**O'MALLEY EFFLUENT, MT RILEY ROAD U071293**

Please find attached an amended design, The beds will now be dose loaded and a pump chamber installed.

## Site and Soil Evaluation Report

DWG NO : SJ102-02  
AMENDMENT: 01  
ISSUE: info

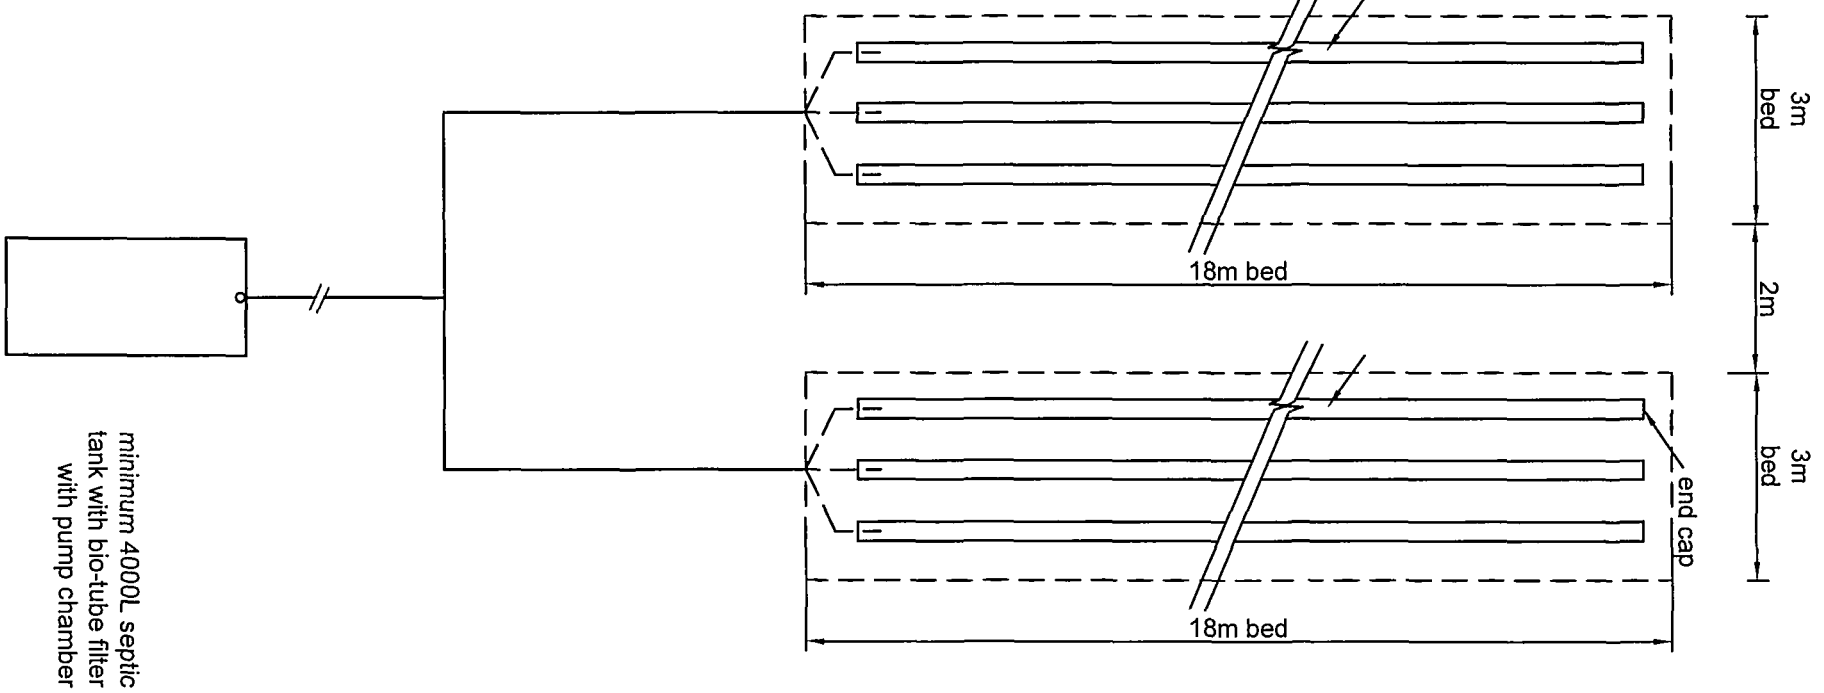
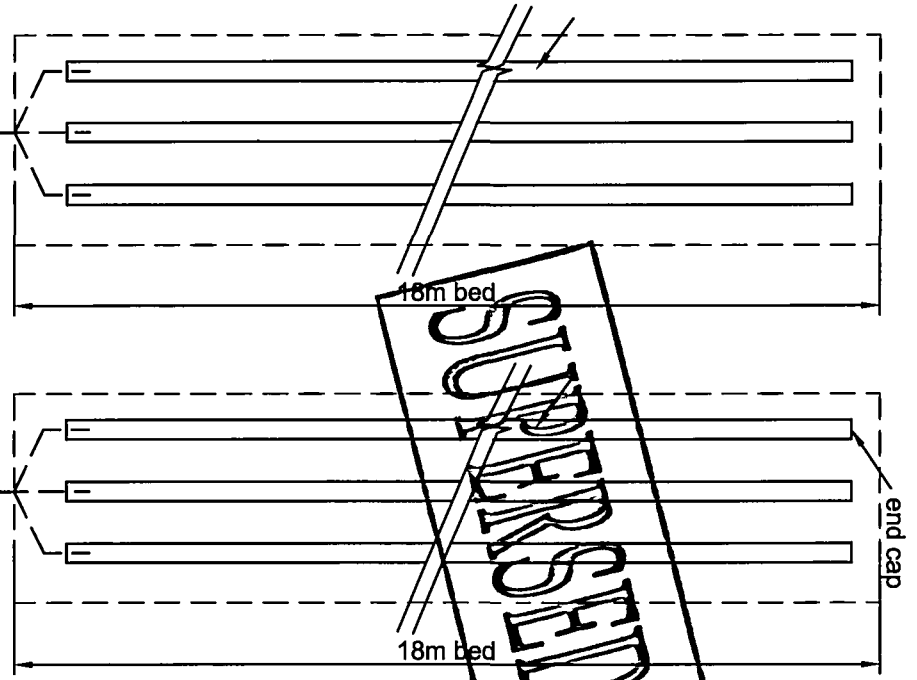
minimum 4000L septic  
tank with bio-tube filter  
with pump chamber
